**GLENORCHY PLANNING AUTHORITY
ATTACHMENTS
MONDAY, 15 MAY 2023**

GLENORCHY CITY COUNCIL**CERTIFICATION OF DRAFT AMENDMENT UNDER SECTION 40F
LAND USE PLANNING AND APPROVALS ACT 1993**

The Planning Authority has prepared the attached draft amendment,
Amendment PLAM-23/01 to the Glenorchy Local Provisions Schedule.

**GLENORCHY LOCAL PROVISIONS SCHEDULE
AMENDMENT PLAM-23/01**

Image 1 – “Place or precinct of archaeological potential” Code Overlay that currently applies on land at 36 Cadbury Road, Claremont to be deleted.

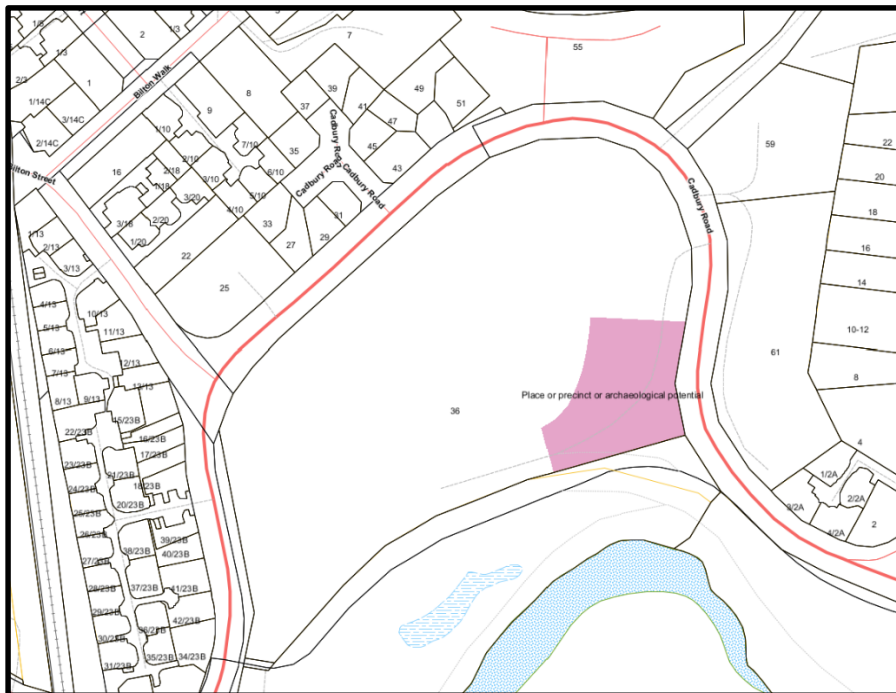
1. Modifying the Code Overlay Maps to delete the spatial application of “Place or precinct of archaeological potential” that currently applies on land at 36 Cadbury Road, Claremont as shown in Image 1 of Annexure 1.
2. Modifying the Code Overlay Maps to insert the spatial application of “Place or precinct of archaeological potential” on land at 26 and 36 Cadbury Road, Claremont as shown in Image 2 of Annexure 1.
3. Modifying the Code Overlay Maps to insert the spatial application of “Place or precinct of archaeological potential” on land at 60 Creek Road, New Town as shown in Image 3 of Annexure 1.

Image 3 – Glenorchy Activity Centre Urban Design Specific Area Plan to be deleted from the General Overlay maps.

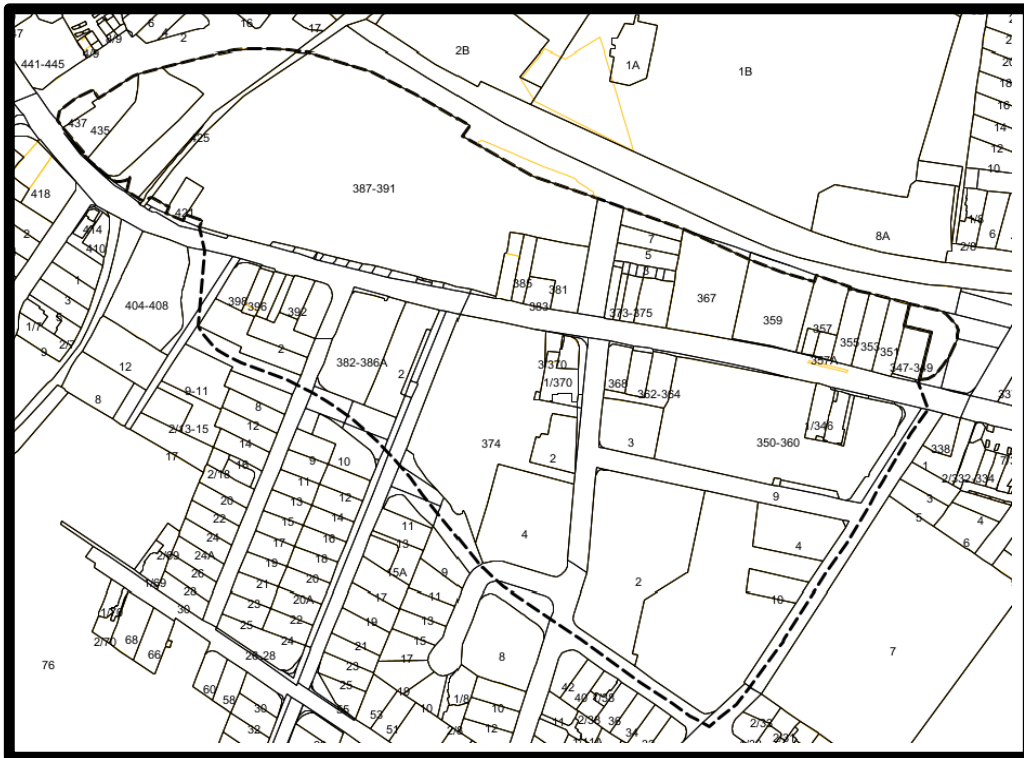
3. Modifying the General Overlay to delete the spatial application of GLE-S8.0 Glenorchy Activity Centre Urban Design Specific Area Plan shown in Image 3 of Annexure 2

Image 4 – Area of GLE-S8.0 Principal Activity Centre Specific Area Plan to be inserted into the General Overlay Maps

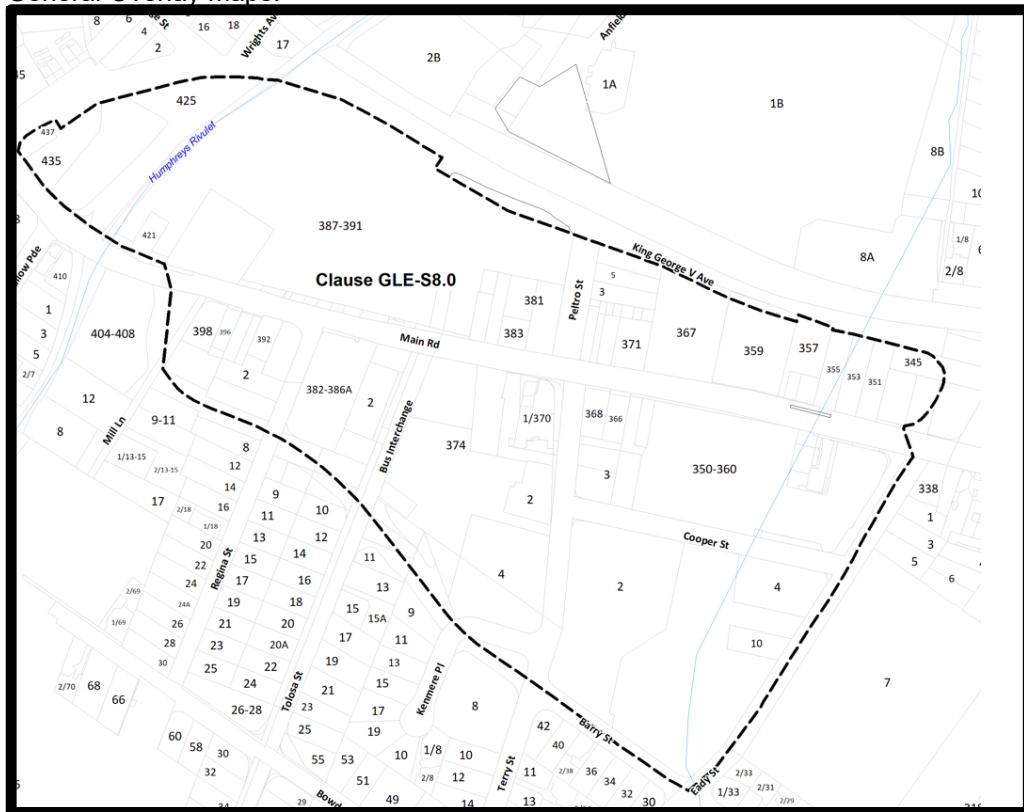
4. Modifying the General Overlay to insert the spatial application of GLE-S8.0 Principal Activity Centre Specific Area Plan as shown in Image 4 of Annexure 2

Image 1 – Land to be included in GLE-S15.0 Northern Apartments Corridor Specific Area Plan

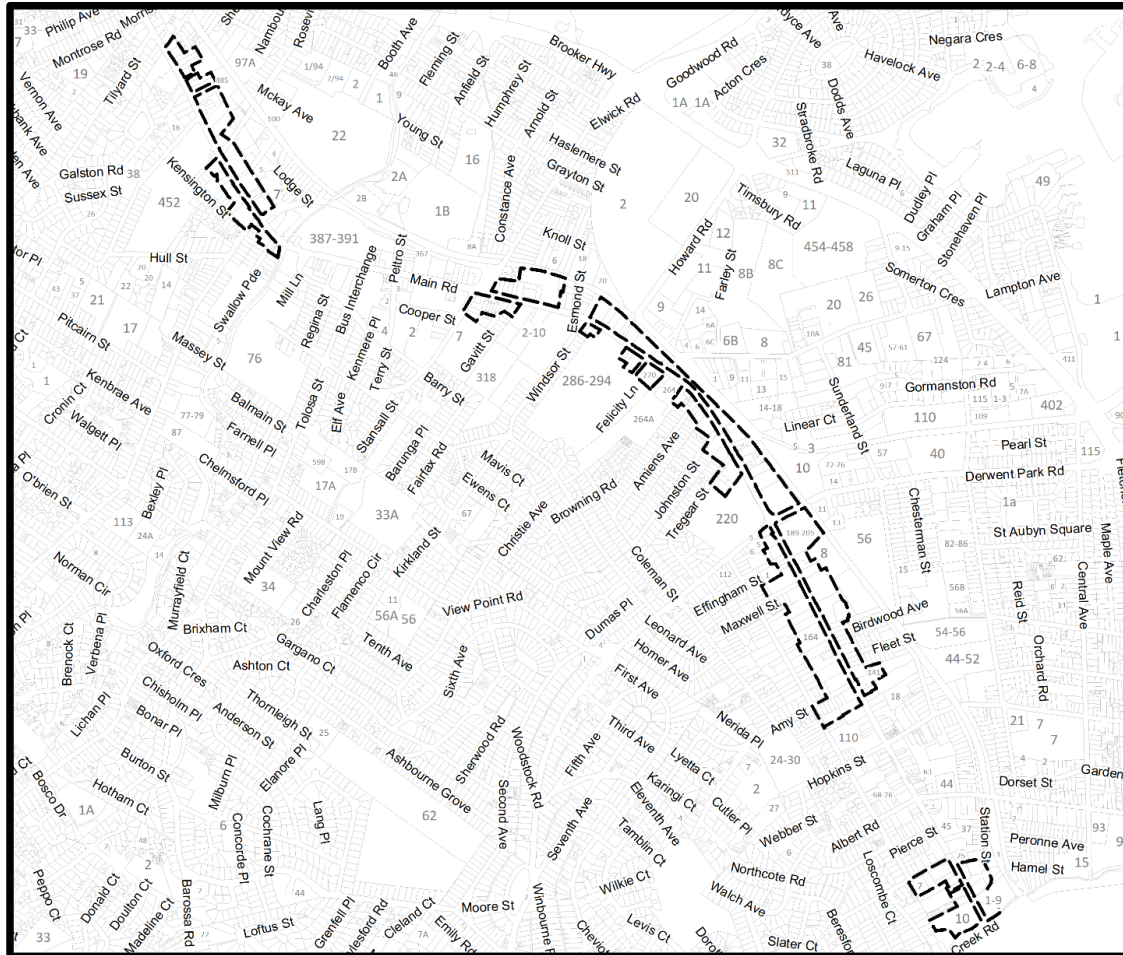
1. Modifying the General Overlay as shown in *Image 1* of *Annexure 2* to show the spatial application of GLE-S15.0 Northern Apartments Corridor Specific Area Plan to the applicable land.
2. Modifying the General Overlay as shown in *Image 2* of *Annexure 2* to show the spatial application of GLE-S15.3 Local Area Objectives of the Northern Apartments Corridor Specific Area Plan to the applicable land.
